Serial No: RA-18-0114

Duke Energy Carolinas, LLC
McGuire Nuclear Station, Unit 2
Docket No. 50-370
Renewed Facility Operating License NPF-17

SUBJECT: License Amendment Request to Revise Technical Specification 4.2.2, "Control Rod Assemblies"

Subject: License Amendment Request (LAR) to Revise Technical Specification (TS) 4.4.2, "Control Rod Assemblies"

Figure 1: Control Rod Locations

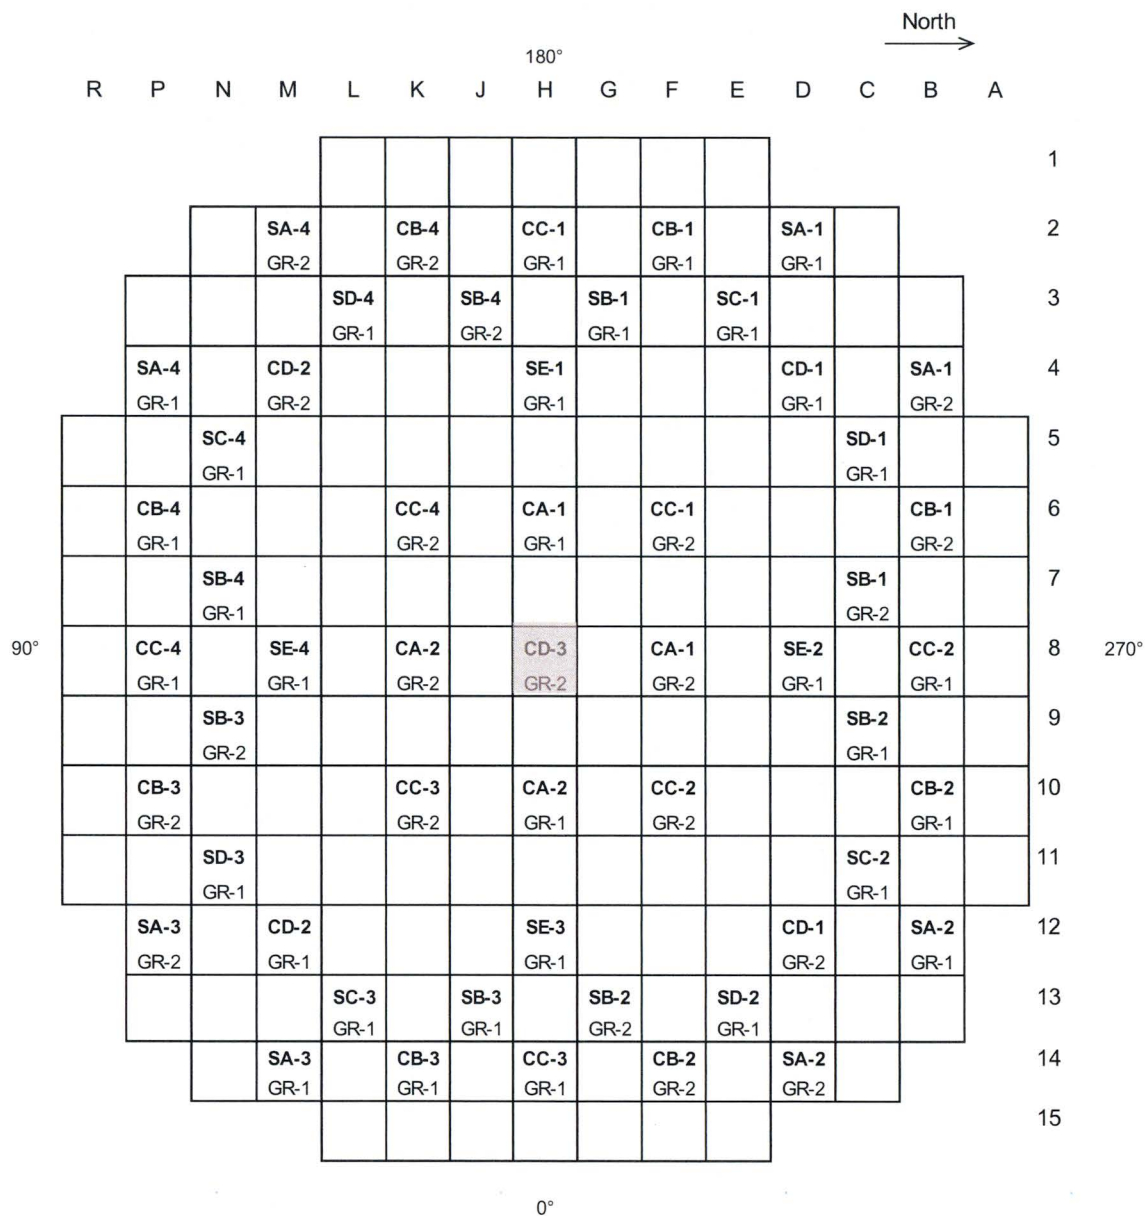
Unit 2 is permitted to operate with 52 control rod assemblies (with no control rod assembly installed in core location H-08) during M2C26.

Control Rod H-08 is located in Control Bank D and is located in the center of the core as shown in Figure 1.
